Gunnison County Environmental Health Board

2:30 p.m. Harmels on the Taylor, LLC, Public Hearing for a variance for the temporary use of vault systems at 6748 County Road 742 OWTS-22-00138

APPLICANT/OWNER:	Harmels on the Taylor, LLC
PROJECT DESCRIPTION:	The applicant is proposing a variance for the temporary use, approximately two years, of vault systems throughout the resort while work to design, permit, and construct a wastewater treatment plant is being undertaken.
CURRENT STATUS OF OWTS APPLICATION:	The OWTS application was denied by the Environmental Health Office because <i>Section 12.C.</i> of the <i>Gunnison County OWTS Regulations</i> prohibits vault systems in the unincorporated areas of Gunnison County.
ENVIRONMENTAL HEALTH BOARD ACTION REQUESTED:	A request for a Public Hearing with the Environmental Health Board for the consideration of a variance to <i>Section 12.C.</i> of the <i>Gunnison County OWTS Regulations</i> has been received.
PROPERTY LOCATION:	6748 County Road 742
AREA DESCRIPTION:	The parcel is located on both sides of County Road 742 at the confluence of Spring Creek and the Taylor River

Site Schematic

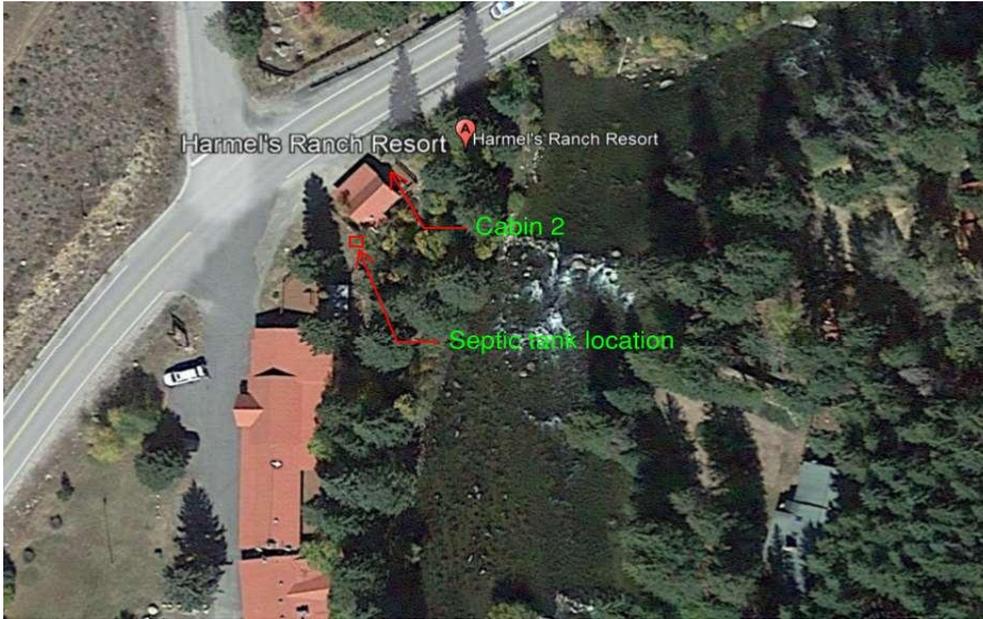
Evaluation Summary and General Notes:			
	Acceptable	Unacceptable	Not Applicable
1) Cabin 2 septic tank		X	
Notes:			
System unacceptable due to root intrusion and not water tight			
2) Pump and Pump Tank			X
Notes:			
3) Soil Treatment Area		X	
Notes:			
Full system needs to be replaced. Current setback requirements cannot be met with current drain field location.

Site Schematic

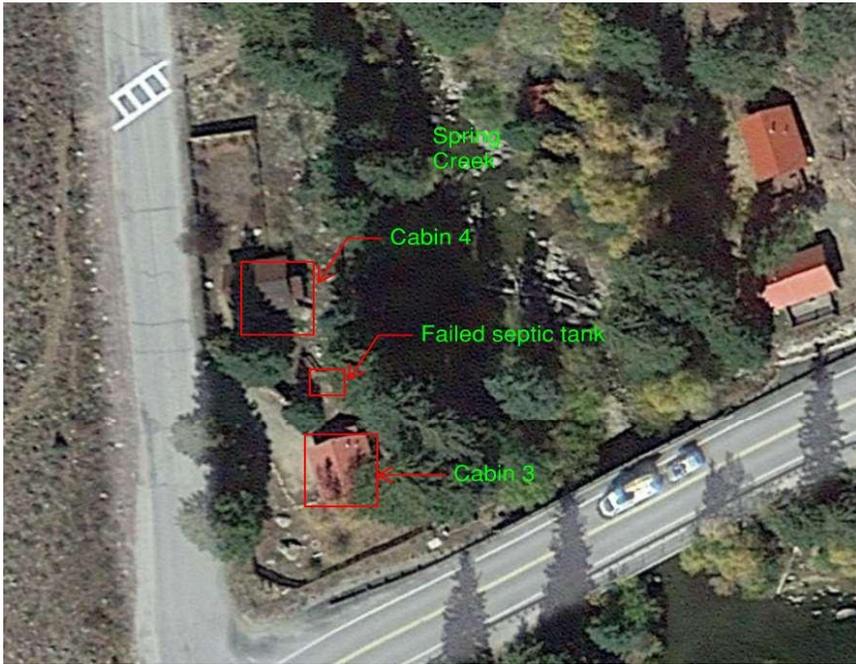
Evaluation Summary and General Notes:			
	Acceptable	Unacceptable	Not Applicable
1) Cabin 3 and 4 septic tank		X	
Notes: <input type="text"/>			
System unacceptable due broken and open septic tank, cleanout to cabin #4 appeared to have been backed up and overflowed			
2) Pump and Pump Tank			X
Notes: <input type="text"/>			
3) Soil Treatment Area		X	
Notes: <input type="text"/>			
Current setback requirements cannot be met with current drain field location. With new tank and Soil treatment area to be relocated.

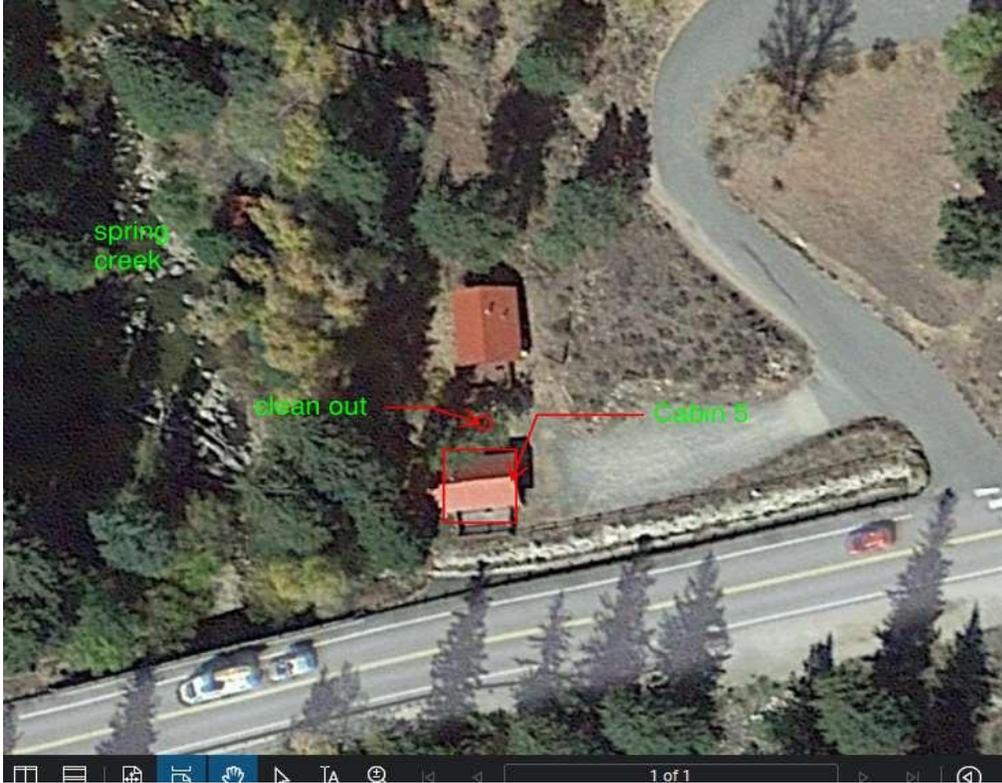
Evaluation Summary and General Notes:			
	Acceptable	Unacceptable	Not Applicable
1) Cabin 5 septic tank	X		
Notes: <input type="text"/>			
Assumed acceptable since no sign of backup or failure, but probably needs to be located and pumped			
2) Pump and Pump Tank			X
Notes: <input type="text"/>			
3) Soil Treatment Area	X		
Notes: <input type="text"/>			
Drain field could not be located, but no sign of failure in assumed treatment area.

Site Schematic

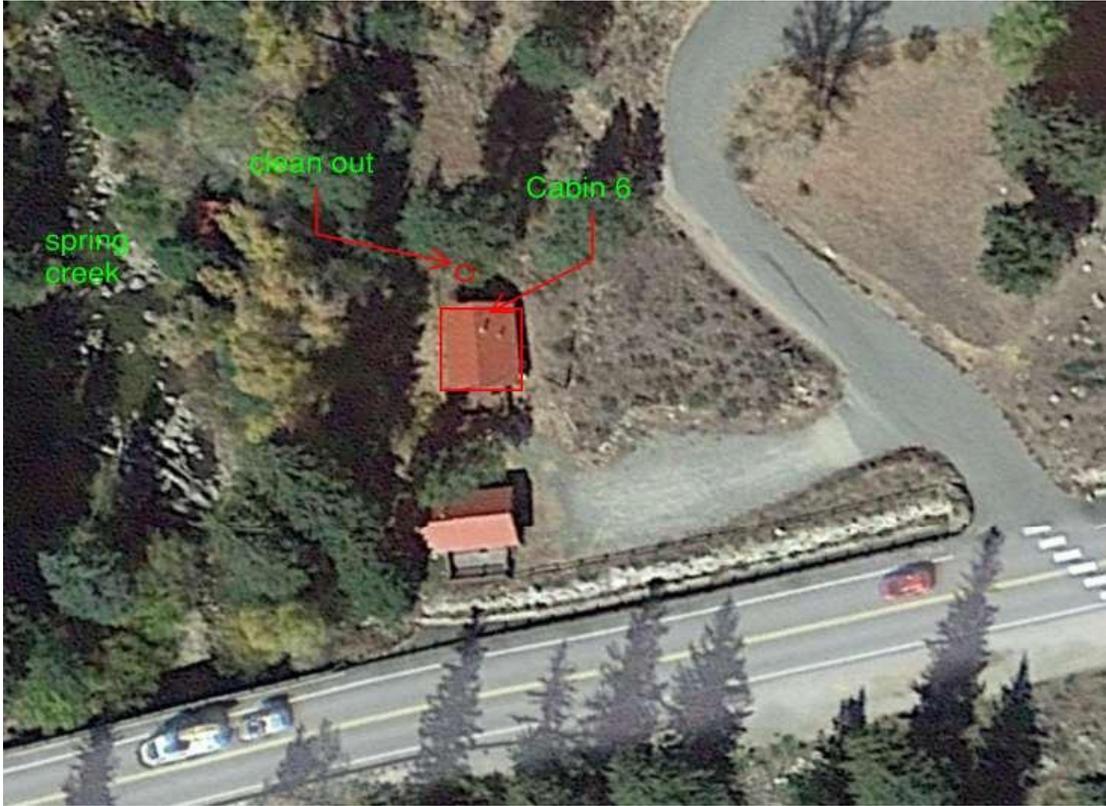
Evaluation Summary and General Notes:			
	Acceptable	Unacceptable	Not Applicable
1) Cabin 6 Septic tank	X		
Notes:	Assumed acceptable since no sign of backup or failure, but recommended to be located and pumped out.		
2) Pump and Pump Tank			X
Notes:			
3) Soil Treatment Area	X		
Notes:	Drain field could not be located, but no sign of failure in assumed treatment area.

Site Schematic

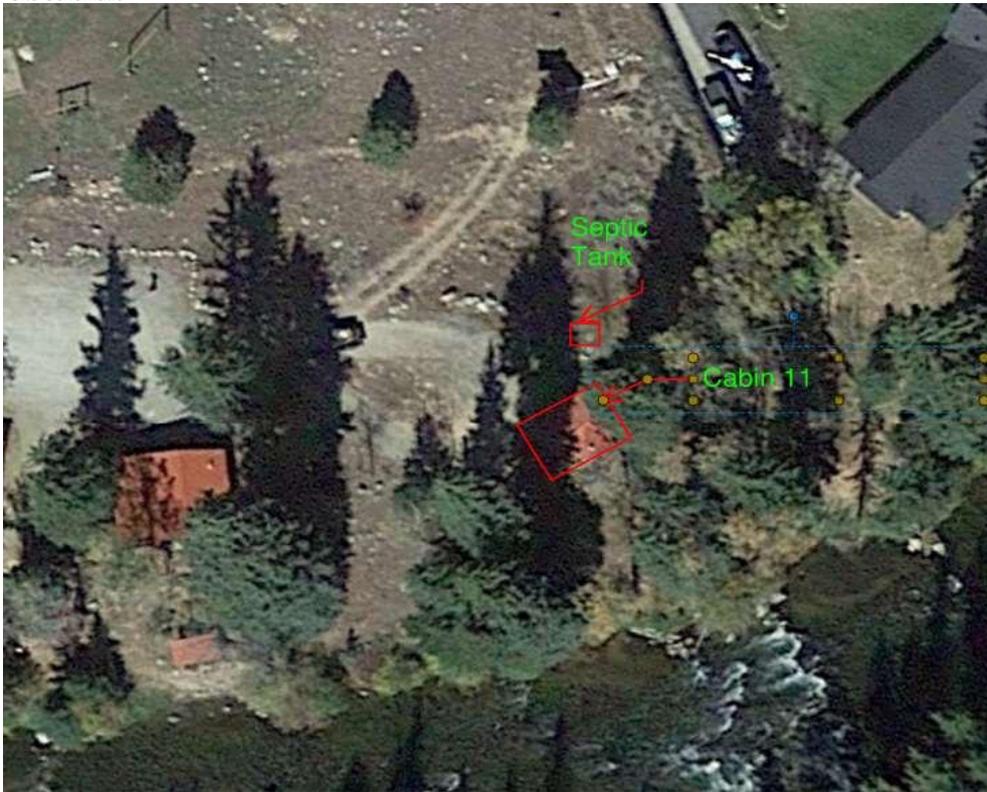
Evaluation Summary and General Notes:			
	Acceptable	Unacceptable	Not Applicable
1) Cabin 11 tank		X	
Notes: <input type="text"/>			
Tank inoperable due to root intrusion. Has not been in use since 2019 and never fixed.			
2) Pump and Pump Tank			X
Notes: <input type="text"/>			
3) Soil Treatment Area			X
Notes: <input type="text"/>			
Size and location of treatment area not able to be determined. System has not been in use since 2019 due to root intrusion. Cabin 11 was apart of signed permitted plans by Williams engineering to combine systems 8,9,10,11, 28-29 and 30-31 but was never built. Plans attached for reference.

Site Schematic

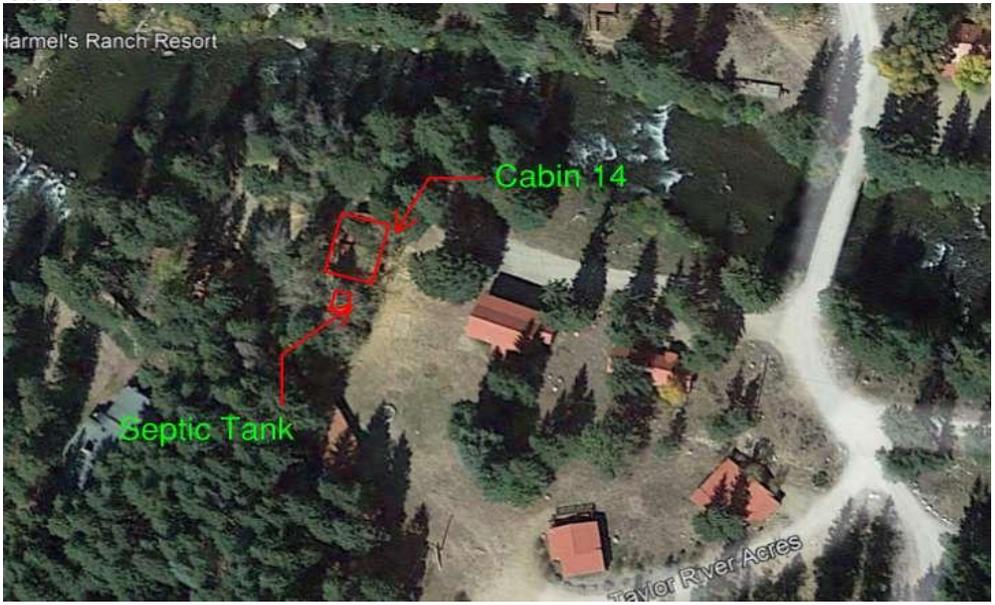
Evaluation Summary and General Notes:			
	Acceptable	Unacceptable	Not Applicable
1) Cabin 14 Tank	X		
Notes:			
Appeared to be working aside from inlet baffle not in place.			
2) Pump and Pump Tank			X
Notes:			
3) Soil Treatment Area			X
Notes:			
Size and location of treatment area not able to be determined.

Site Schematic

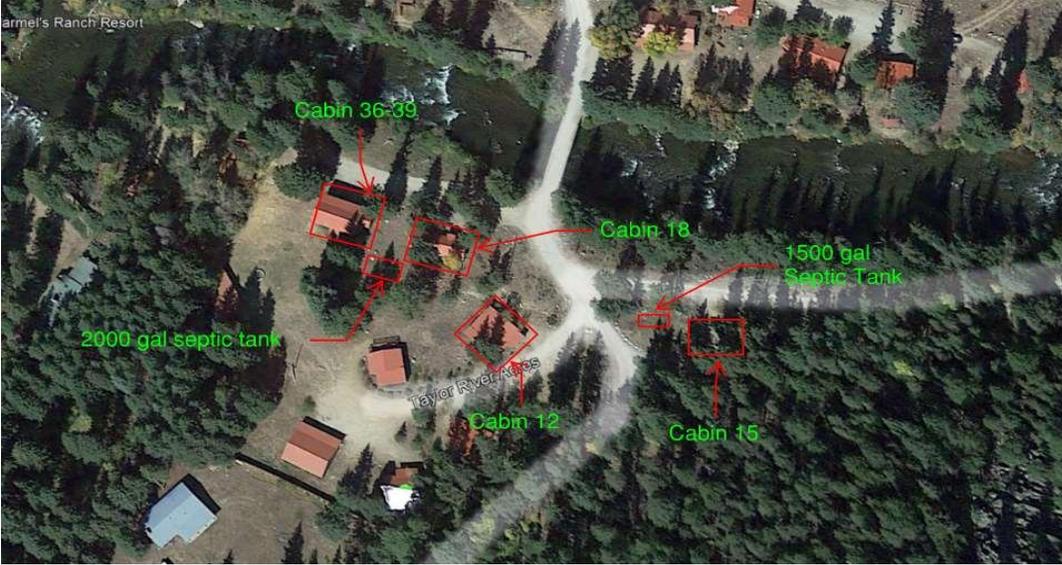
Evaluation Summary and General Notes:				
	Acceptable	Unacceptable	Not Applicable	
1) Cabin 15, 12, 18, 36-39 Tanks	X			
Notes:	Acceptable and in good shape assuming baffles are installed.			
2) Pump and Pump Tank			X	
Notes:				
3) Soil Treatment Area	X			
Notes:	Soil treatment area assumed to be acceptable as no evidence or indication of failure or backup could be found. But no cleanouts. In open grassy area to the southwest of 36-39.

site schematic

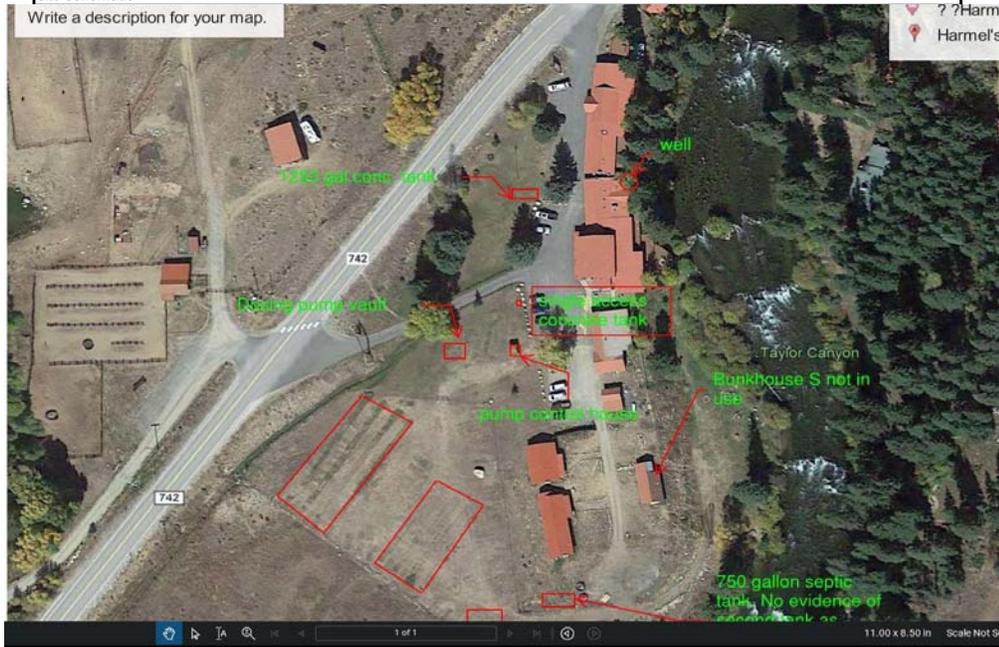
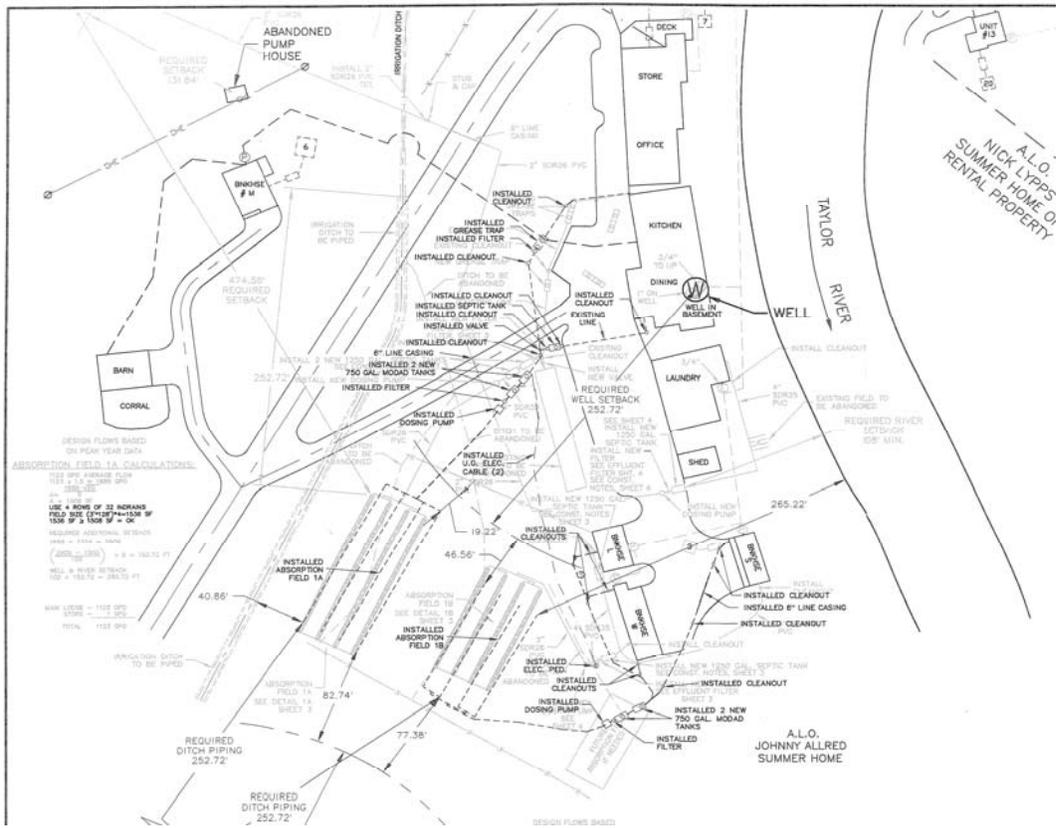
Evaluation Summary and General Notes:			
	Acceptable	Unacceptable	Not Applicable
1) Commercial and Bunkhouse Pretreatment Unit (septic tank)	X		
Notes:			
All tanks seem to be in working order. Sludge, scum and water depths all seem to be appropriate aside from the tank that was unable to be accessed. Pipe and cleanout from Bunkhouse S not in use and seems to be plugged.			
2) Pump and Pump Tank	X		
Notes:			
Pump vaults in good working conditions. As previously mentioned in this report, pumps for commercial dosing tank should be lowered so the pump is operating at more frequent intervals. Pump vault for bunkhouse seemed to be working well			
3) Soil Treatment Area	X		
Notes:			
Soil treatment area had no indication or evidence of failure. No obscure smells were observed and both fields 1A and 1B seem to be in working condition.

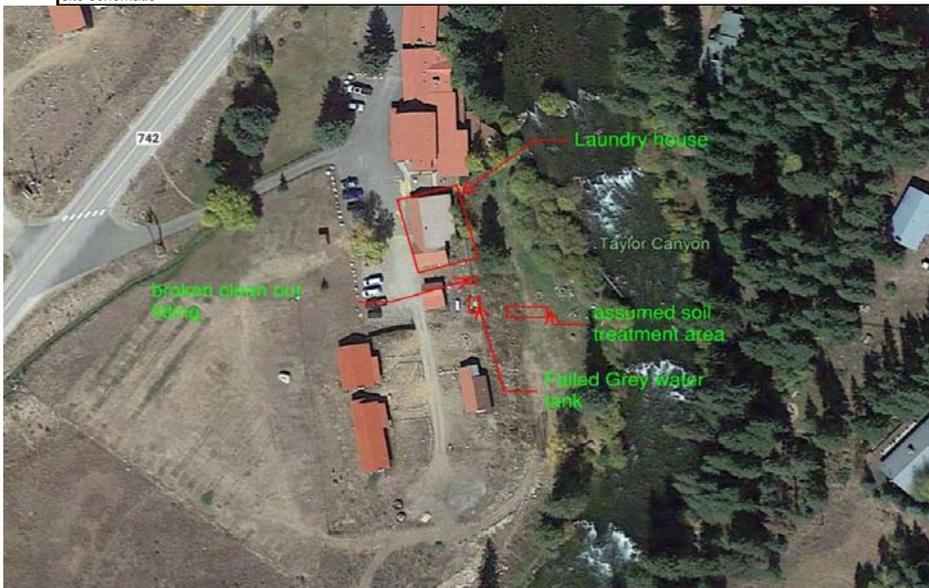
Evaluation Summary and General Notes:			
	Acceptable	Unacceptable	Not Applicable
1) Laundry Grey Water Tank		X	
Notes:			
System unacceptable as drain line is disconnected. Also setback from Taylor River doesn't meet current code. And tank 1/2 exposed and above ground and water level lower than outlet.			
2) Pump and Pump Tank			X
Notes:			
3) Soil Treatment Area		X	
Notes:			
Current treatment area not in use as water is not making it to the tank or soil treatment area. Current soil treatment area doesn't meet setback requirements from the Taylor River.			
site schematic
